ON-SITE SEWAGE DISPOSAL SYSTEM 05-368170
HOWARD COUNTY HEALTH DEPARTMENT
BUREAU OF ENVIRONMENTAL HEALTH

ADDRESS: 8504 Edenton Road (PHONE NUMBER: (301) 498-1059)

SUBDIVISION: Beaufort Park LOT NUMBER: 6, Block E

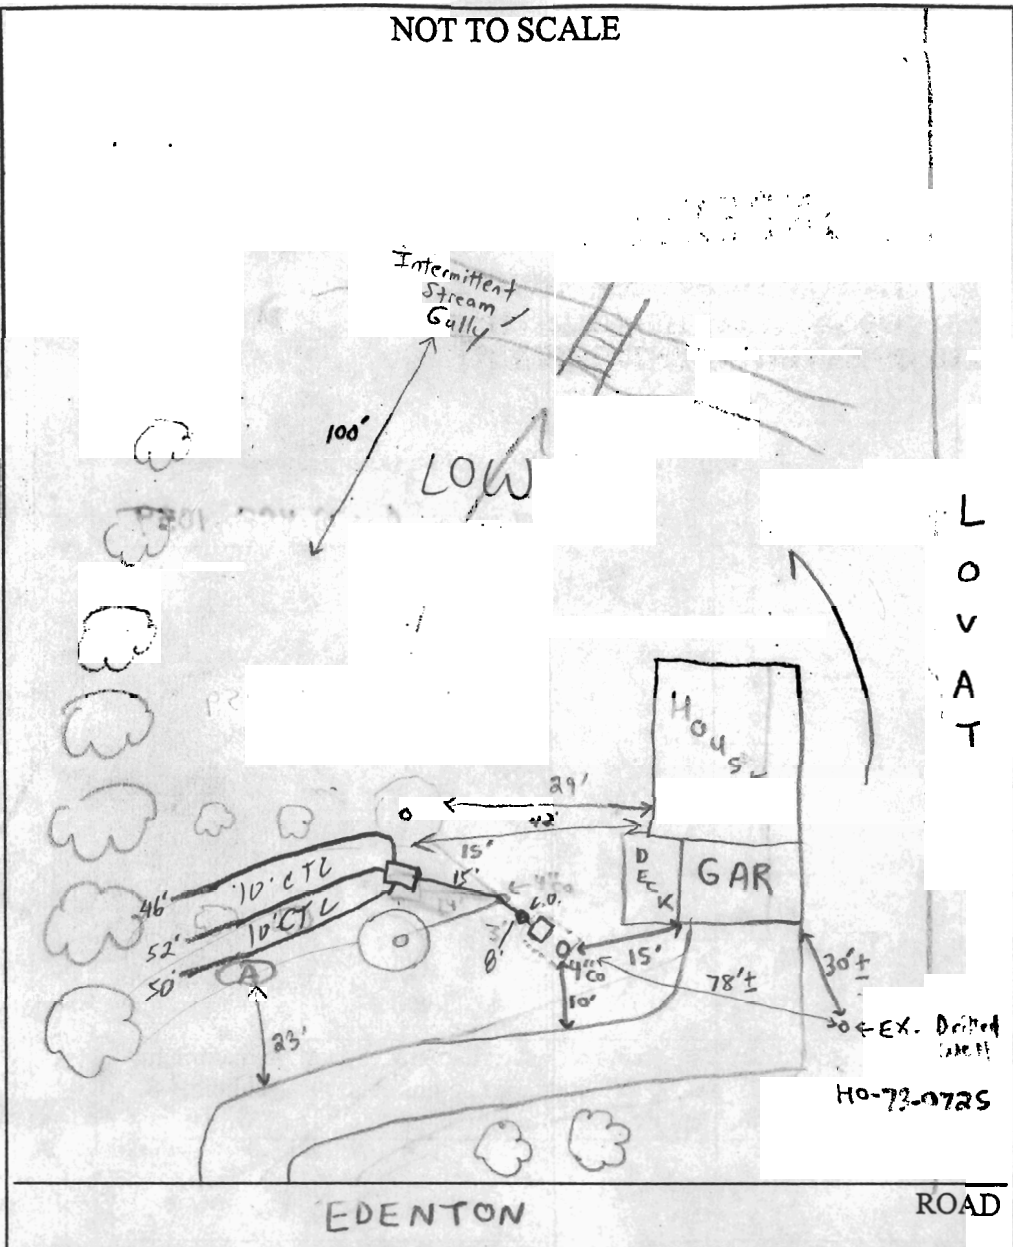
| TRENCHES: | Trench to be 2 feet wide. Inlet 5.5-6 feet below original grade. Bottom maximum depth 10 feet below original grade. Effective area begins at 5 feet below original grade. 4 feet of stone below distribution pipe. |
| PURPOSE: | Repair to support future building permit addition. Existing septic tank/dry well expected to be moved. Existing septic trench is believed to be installed perpendicular to contour. - SRK |

PRE-CONSTRUCTION 7/11/02-MET CONTRACTOR IN FIELD, DUG PERC HOLE IN LOCATION (A) SEE SOIL PROFILE, RUN TRENCHES AS DISCUSSED IN FIELD, CHECK INTEGRITY INSTALLATION OF TANK & BAFFLES, DISCONNECT & ABANDON (FILL W/STONE) EXISTING DRYWELLS, TRENCHES MAY HAVE TO BE INSTALLED SLIGHTLY OFF CONTOUR BUT BOTTOMS WILL BE LEVEL - (SRK) 5/5/03-MET W/ K&K EXCAVATING & OWNER (MR. DOWNING) DISCUSSED REVISED LAYOUT (SAME AS BEFORE) - (SRK/FA) 5/12/03 OK to cover all work (SO)
